# Access Compliance Report

## Public Rights-of-Way

### (Curb Ramps)

Intersection ID: 50867	Main Street: REAMES_RD	Cross Street: BROOKLINE_RIDGE_DR	Location:	N
ADA ID: 49223FACD02F	Ramp Type: Perp	Initial Pass/Fail: Fail	Overall Compliance: No	Severity Score: 22.5
Codes/Mitigation Info/Possible Solution		Field Measurements/Component Compliance

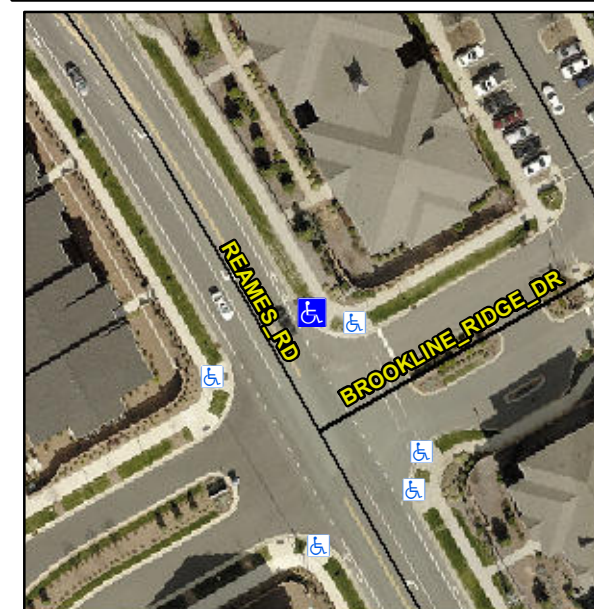
**Not Found, R304.5.1, R304.2.2, R304.5.3**

Compliance	Description	Data	Compliance	Description	Data
N/A	Ramp Length (in)	94.0	No	Ramp Slope (%)	8.5
No	Ramp Width (in)	47.0	No	Ramp XSlope (%)	2.3
N/A	Flare Type LT	N/A	N/A	Flare Type RT	N/A
N/A	Flare Slope LT (%)	N/A	N/A	Flare Slope RT (%)	N/A
N/A	Flare Traversable LT?	N/A	N/A	Flare Traversable RT?	N/A
N/A	Landing Length (in)	N/A	N/A	DWS Provided?	N/A
N/A	Landing Width (in)	N/A	N/A	DWS Contrast?	N/A
N/A	Landing Slope (%)	N/A	N/A	DWS Length (in)	N/A
N/A	Landing X Slope (%)	N/A	N/A	DWS Full Width?	N/A
N/A	Landing Curb? (Y/N)	N/A	N/A	DWS Offset (in)	N/A
N/A	Shared Landing?	N/A			
N/A	Gutter Ponding?	N/A	N/A	Gutter Slope (%)	N/A
N/A	Gutter Lip Ht (in)	N/A	N/A	Gutter X Slope (%)	N/A
N/A	Painted X Walk1?	No	N/A	Painted X Walk2?	N/A
	X Walk 1 Direction	To W		X Walk 2 Direction	N/A
N/A	X Walk 1 Width (in)	N/A	N/A	X Walk 2 Width (in)	N/A
	X Walk 1 Slope (%)	4.8		X Walk 2 Slope (%)	N/A
	X Walk 1 X Slope (%)	1.2		X Walk 2 X Slope (%)	N/A

**Remove & Replace Entire Ramp.**
